**PSEG** Public Service  
Electric and Gas  
Company

HOPE CREEK GENERATING STATION  
DOCKET NO. 50-354  
FSAR COMMITMENT STATUS THROUGH JULY 1984

ATTACHMENT I  
HOPE CREEK GENERATING STATION  
FSAR COMMITMENT STATUS THROUGH JUNE 1984

FIGURE 9.1-3

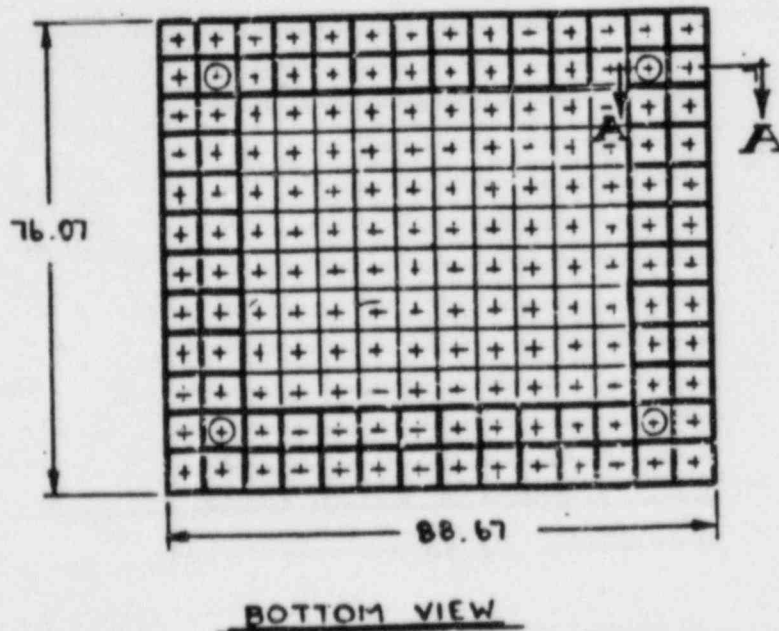
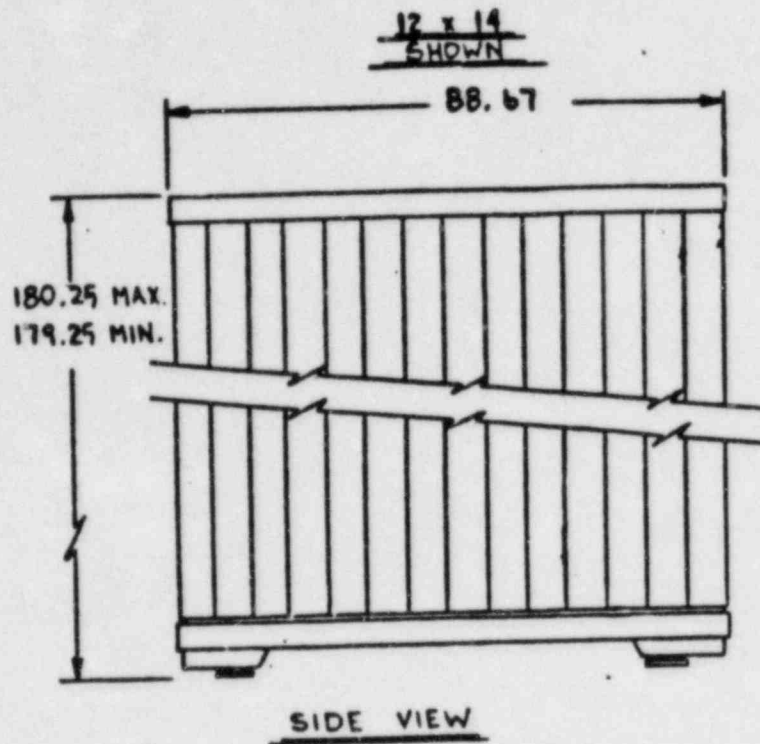
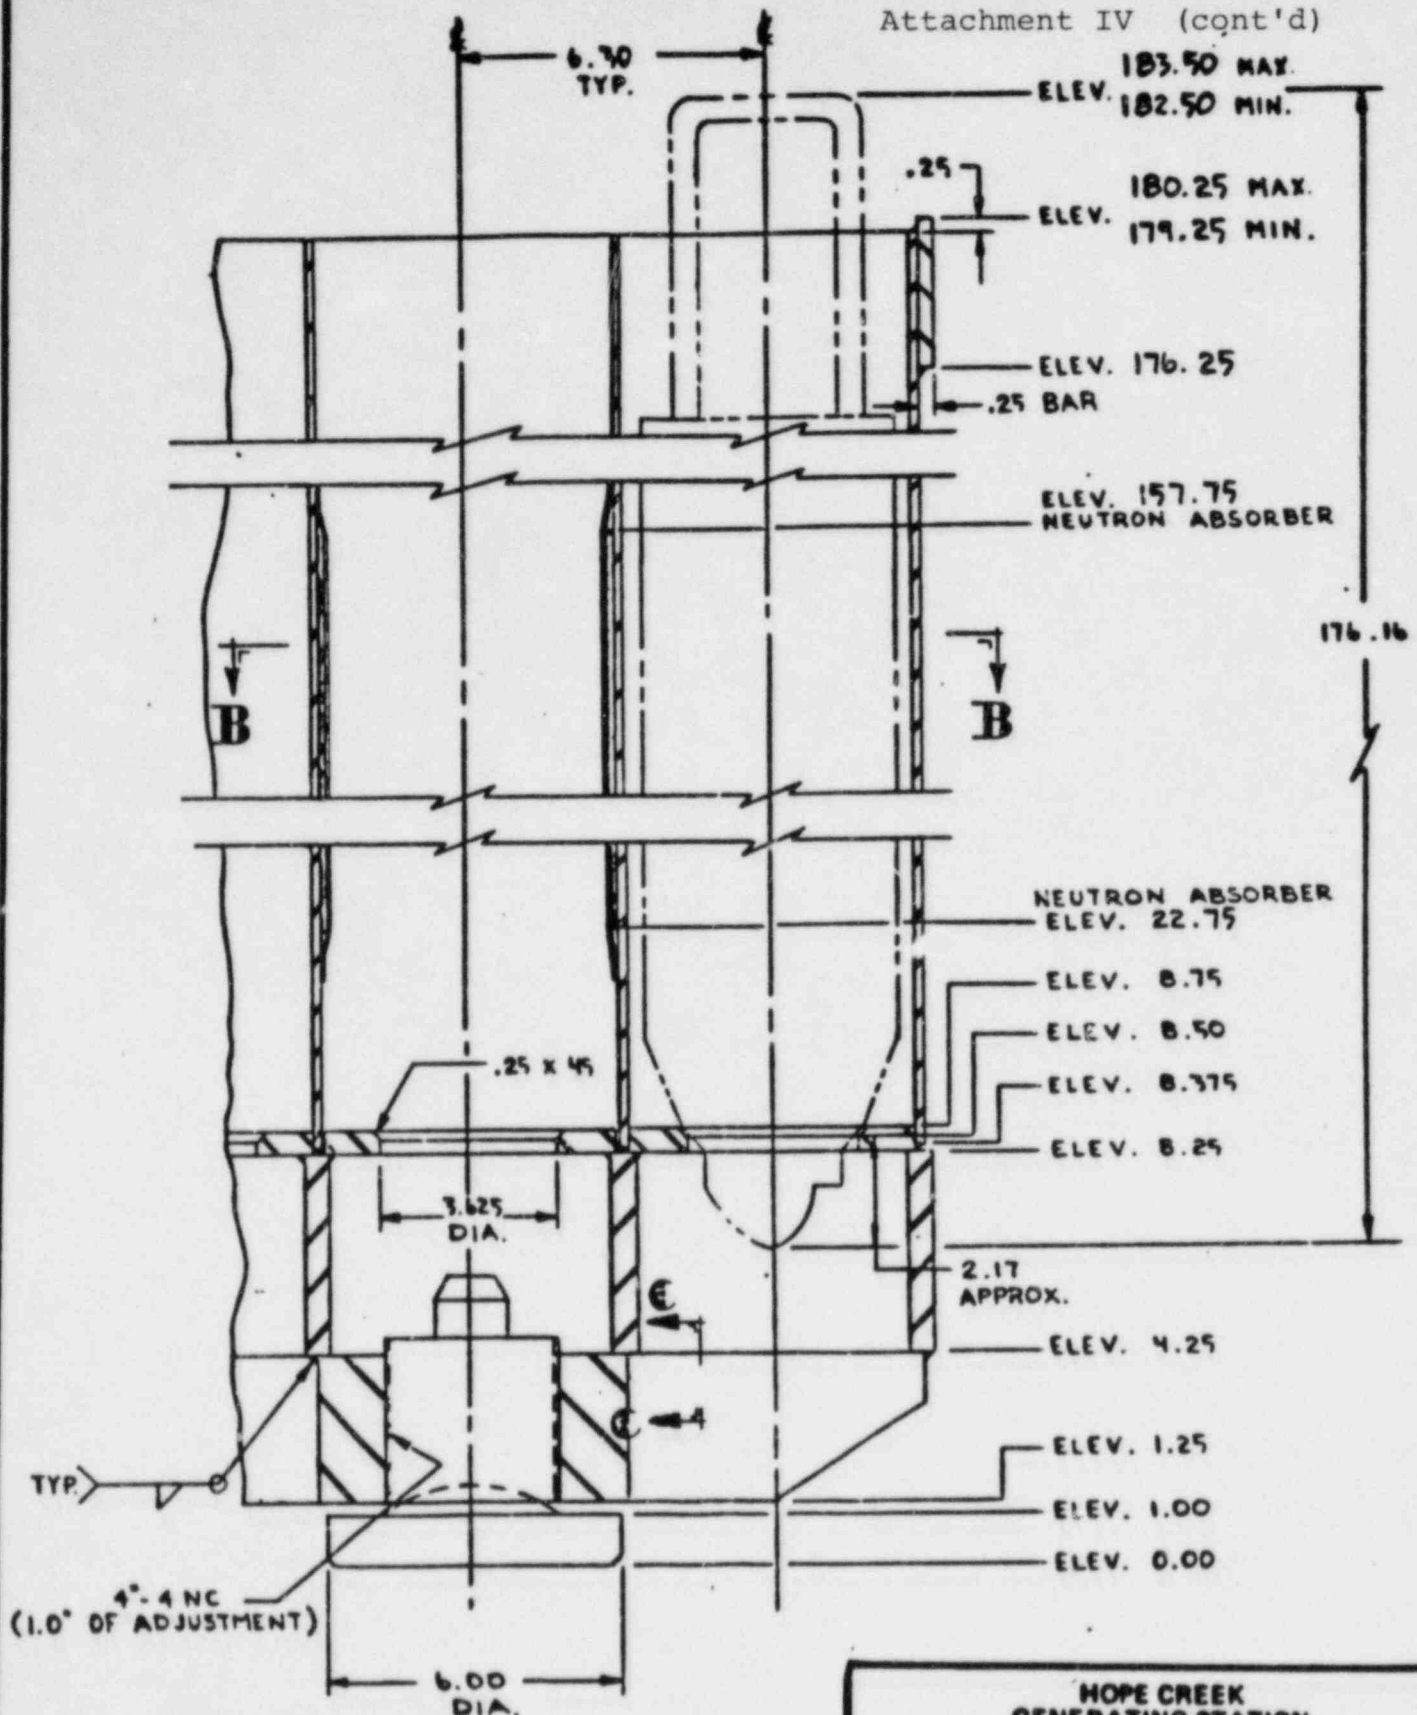
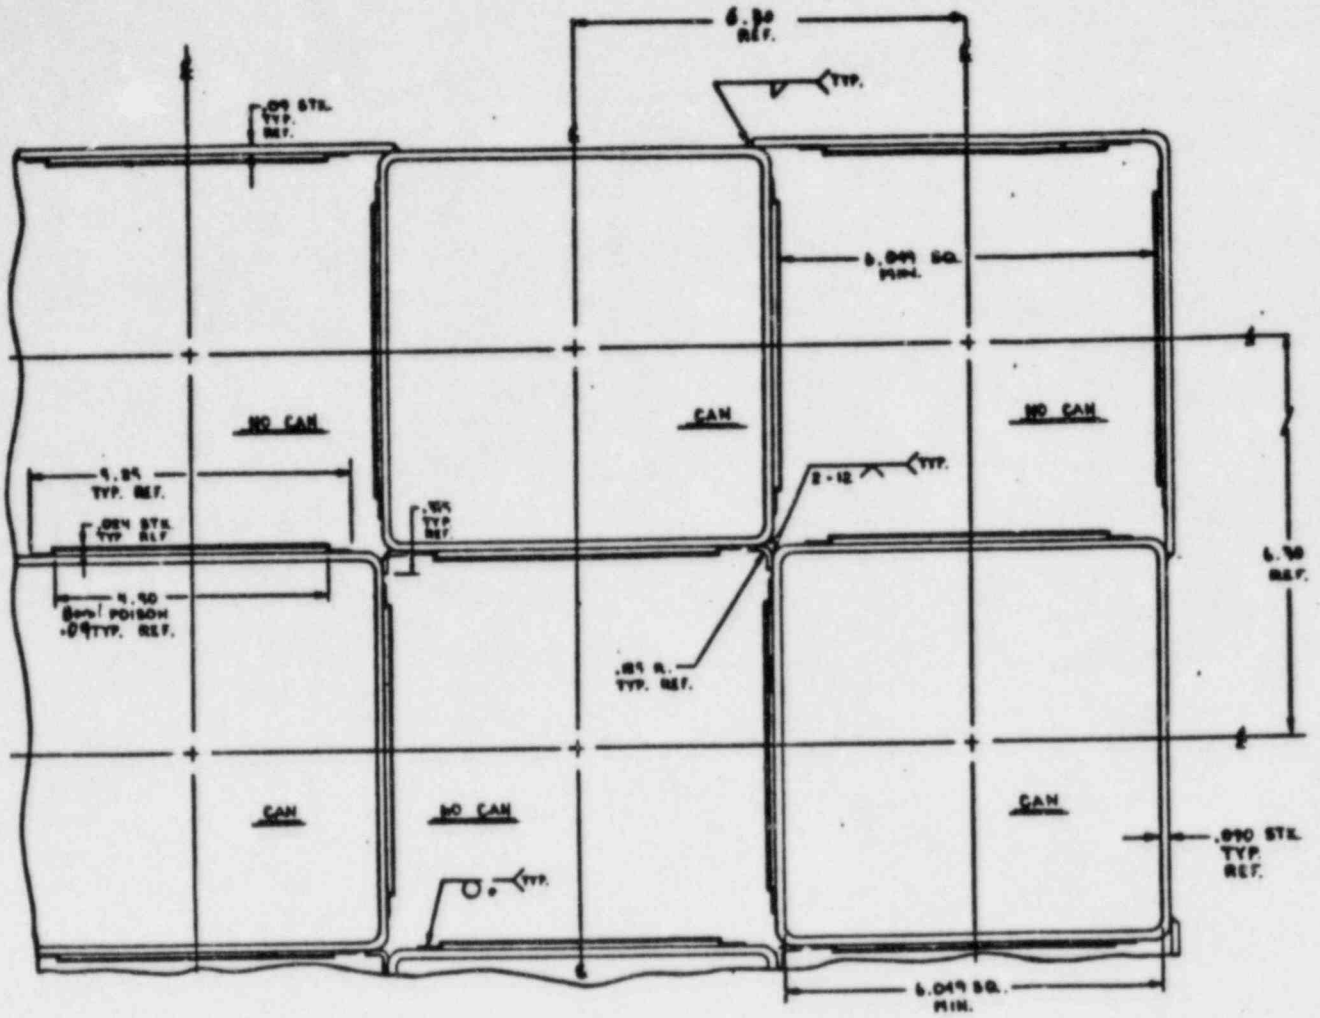
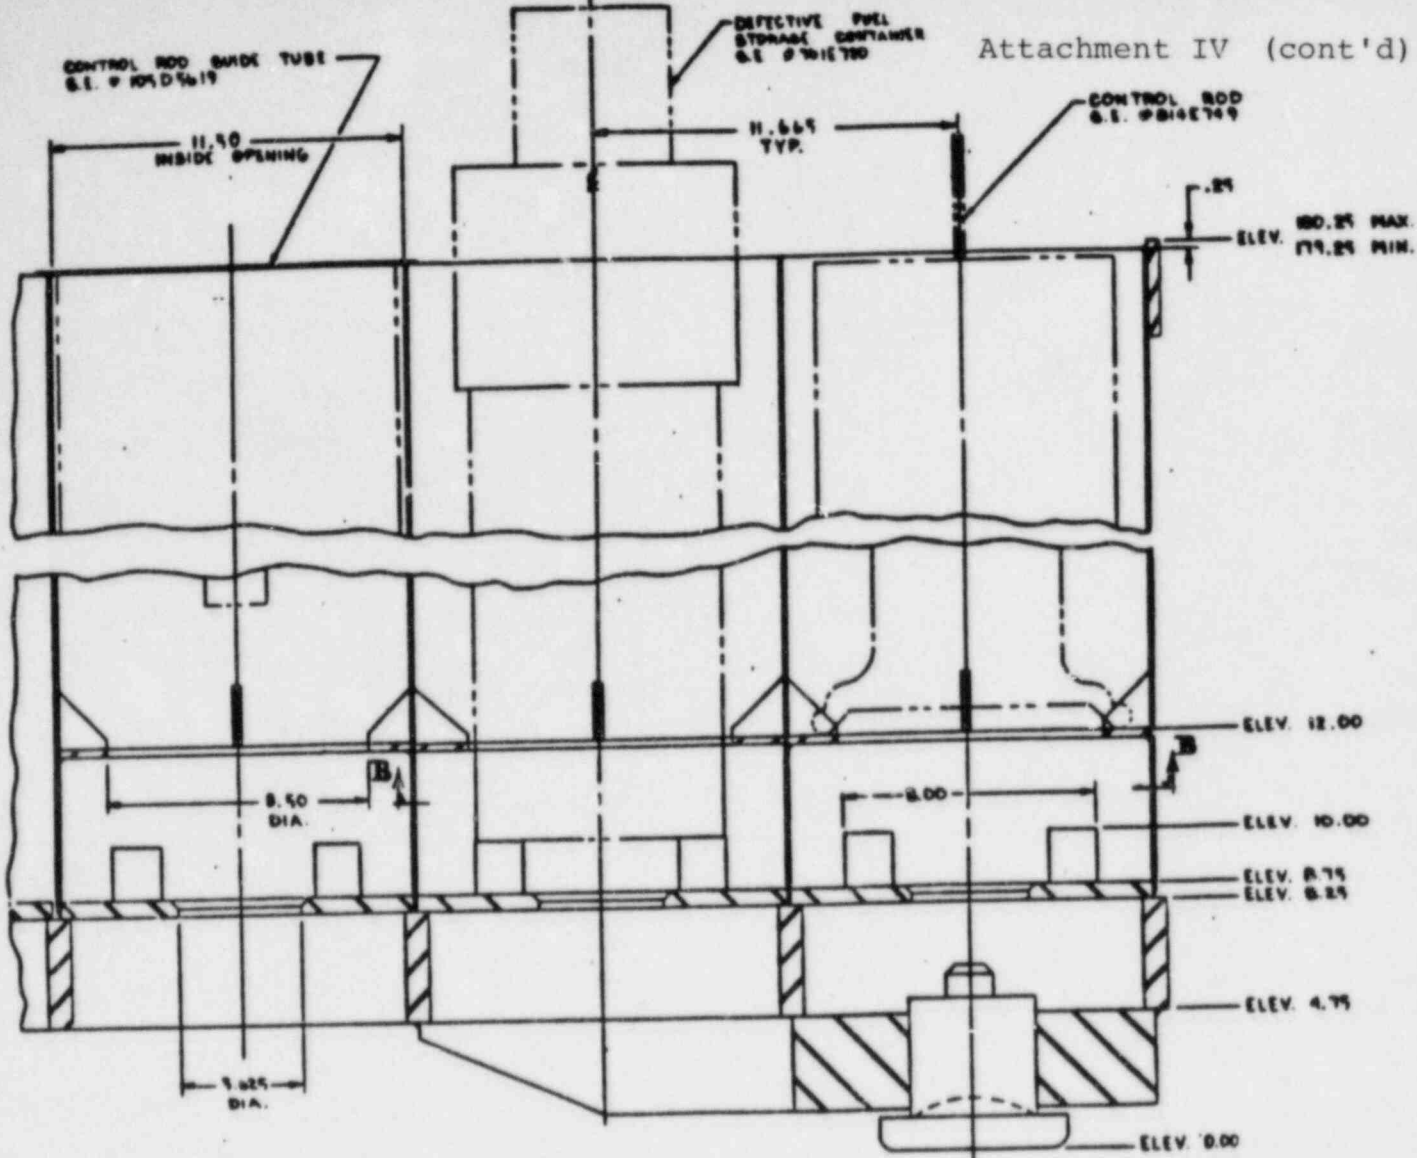
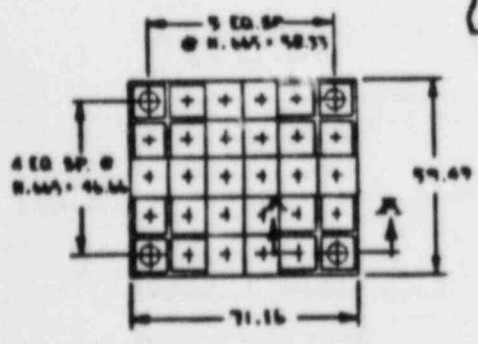
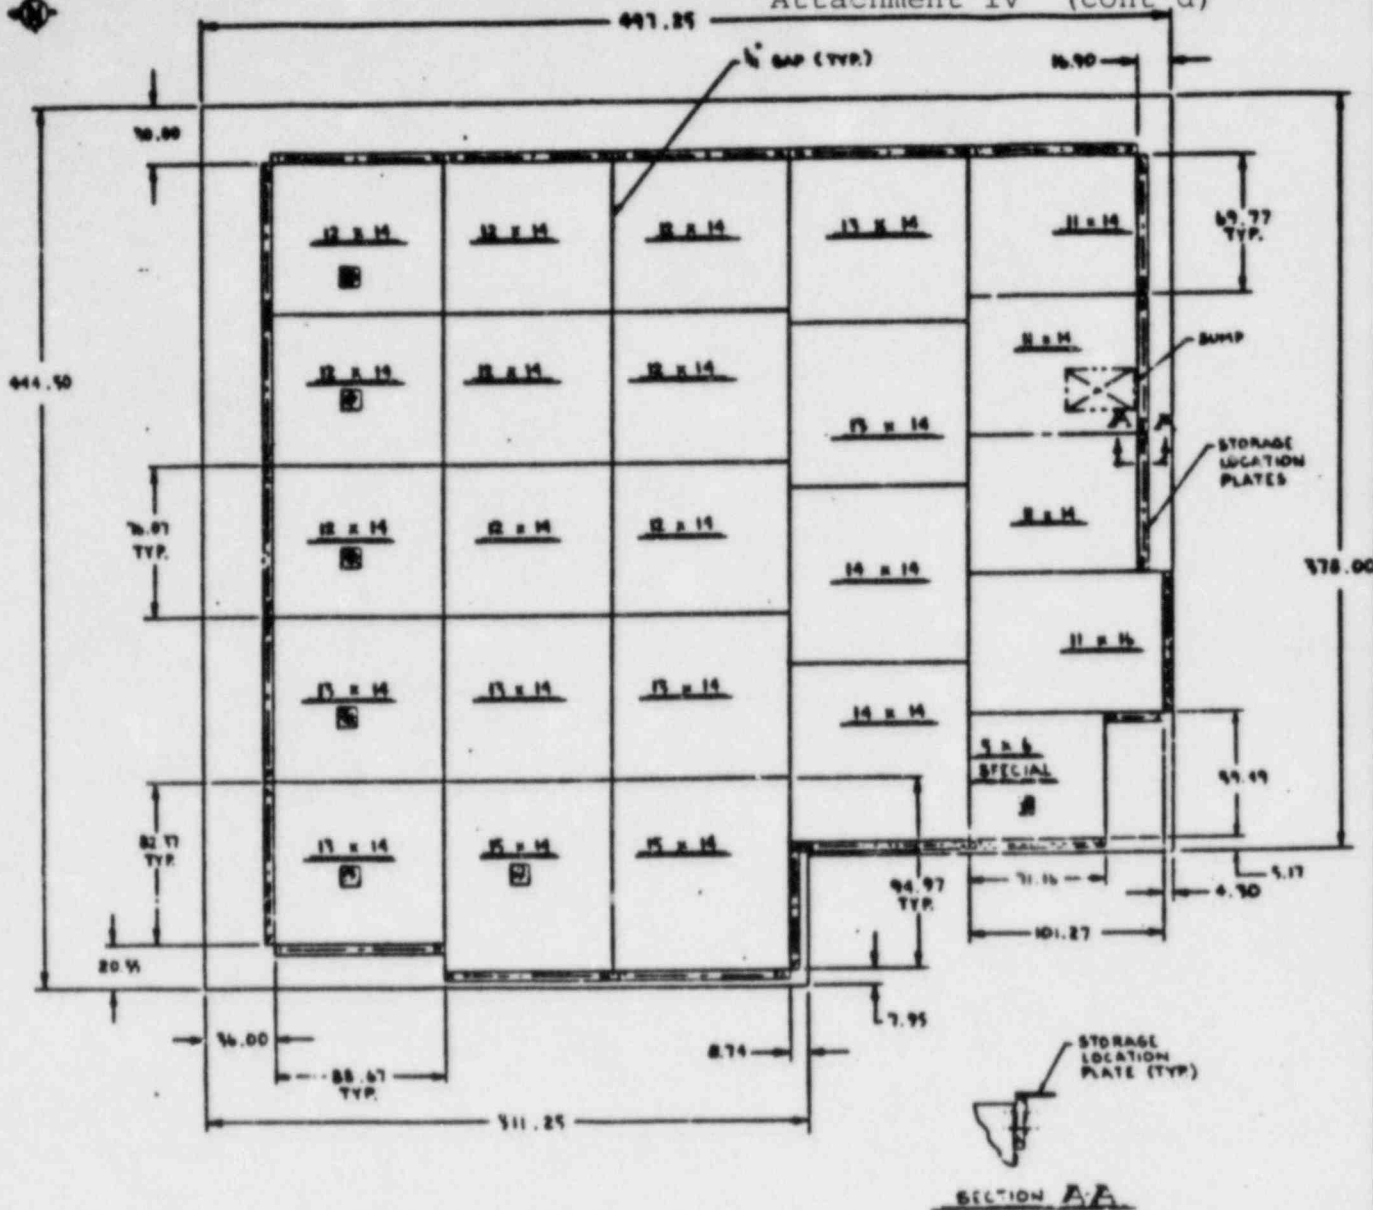
QUESTION 281.2 (SECTION 9.1.2)

Figures 9.1-3 and 9.1-4 are shown as to be supplied later.  
Supply these figures or a date by which they will be provided.

*Section 9.1.2 has been revised to provide*  
Figure 9.1-3, A Typical Spent Fuel Rack, and Figure 9.1-4, Spent  
Fuel Rack Arrangement In Fuel Pool ~~will be provided by June 1~~  
~~1988.~~
